Takitimu North Link Stage 2
Specimen Hydraulic Design Report
Stormwater Management

Review comments by Graham Macky

9th November 2023, amended 4th January 2023

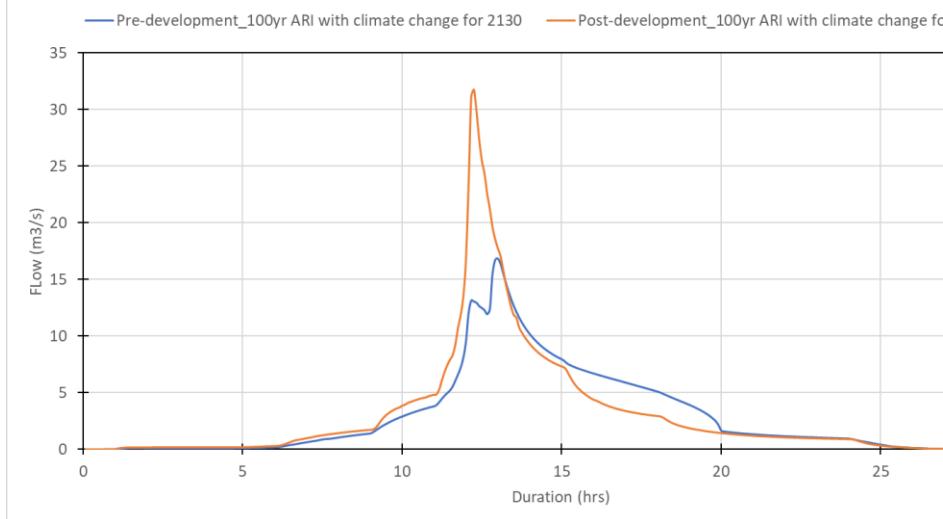
Fig 2-2 and Fig 2-3	A passing comment that I've made elsewhere: this design hyetograph and this infiltration pattern are together very conservative for	Noted

small catchments, because the catchment is calculated to be saturated before the short-term design events begin. The report says as much on p8.		
P8	It's not stated how the hydrological parameters have been deduced from the soil characteristics and other information. However, the chosen parameter values seem reasonable.	<p>The soil hydrological parameters based on the soil characteristics were taken from EPA SWMM reference Manual and Rawls et al. (1983). We have already stated how we have estimated infiltration parameters in last paragraph of page 7 of the report.</p> <p>However, we have added following text (blue coloured) for clarity:</p> <p>Infiltration was estimated based on typical hydraulic characteristics for typical soil texture classes, that were taken from the EPA SWMM-5 Manual and Rawls et al. (1983). Soil textures from the site were derived from available geotechnical information, NZ Landcare Research S-Map Online, NZ Landcare Research LRIS Soils Portal, NZ National Soils Database and site observation and take into account general soil type, the clay content, and the moisture content.</p>	Resolved/ good anyway ...

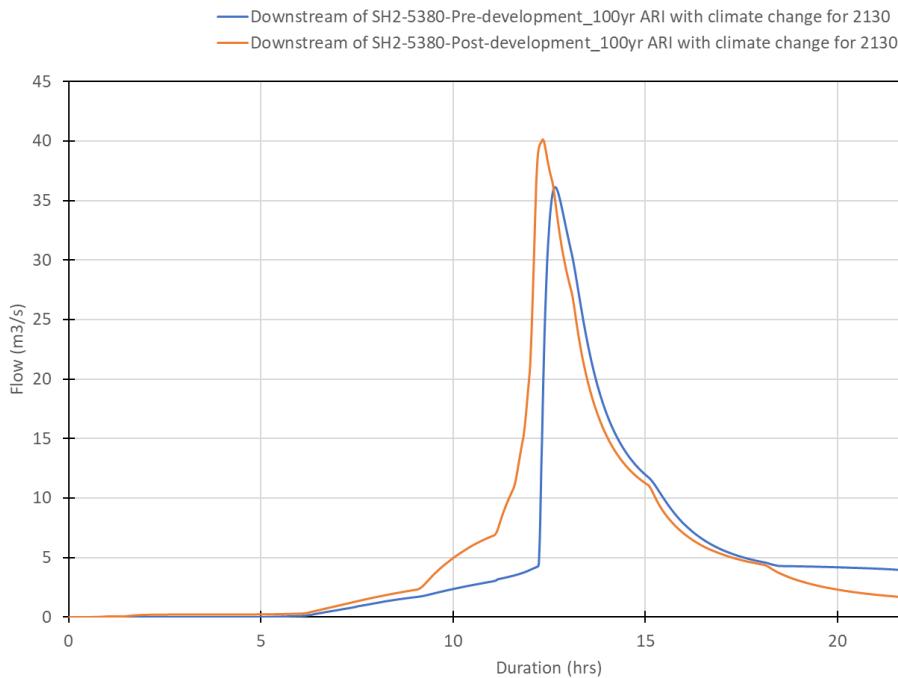
residence time. The BoP Guidelines are ambivalent – mentioning oioi favourably but elsewhere saying “it should be grass”		
P14 3.2 para 2 and Fig 3-1 (p15)	I found the text and map took a while to understand. Could you mark on Fig3-1 either the swale direction of flow or the sub-catchment boundary (all areas draining via the pipe and swale to Waipapa Stream)?	Swale flow arrows have been added to report figures and appendix figures.	Resolved
	Could the pipe and swale to Waipapa Stream be shown and identified in Fig 3-1?	Pipe has been called out.	Not sure Comment Resolved
P15	I agree that no attenuation is needed before discharge into Waipapa Stream.	Noted	
	I also agree that the cut slope part of RO1B does not need attenuation. If its	Noted

vegetation includes grass or other ground cover, its runoff won't need treatment either.		
	But has RO1B been labelled RO1A in Fig 3-1?	No RO1B was missing. We have added RO1B in Fig 3-1.	Comment Resolved
P16 RO2B-E	This all looks satisfactory. But what rainfall event equals the capacity of the catchpits? If it's less than the 100-year event, does the excess runoff actually reach the pond?	<p>The catchpits capacity is not equated to any rainfall event rather the catchpits will be spaced so that they meet the flow spread requirements for both 10yr and 100yr ARI storm events as per P46 Stormwater Specification by Waka Kotahi NZTA (2016).</p> <p>The total flow at the catchpit is the sum of the runoff from the sub-catchment and the bypass flow from the previous catchpit, except for the most upstream catchpit. More catchpits need to be added in case the spread of the flow is larger than the allowable spread. Further, additional catchpit will be provided at lowest point on the main traffic lane alignment so that the total flow is captured and conveyed.</p> <p>The catchpit spacing needs to be completed by design/construct team and hence, more in line with a review to ensure that a detailed design is compliant with consent conditions.</p>	Good, but we should say "all runoff from up to the 100-year ARI event" Comment Resolved
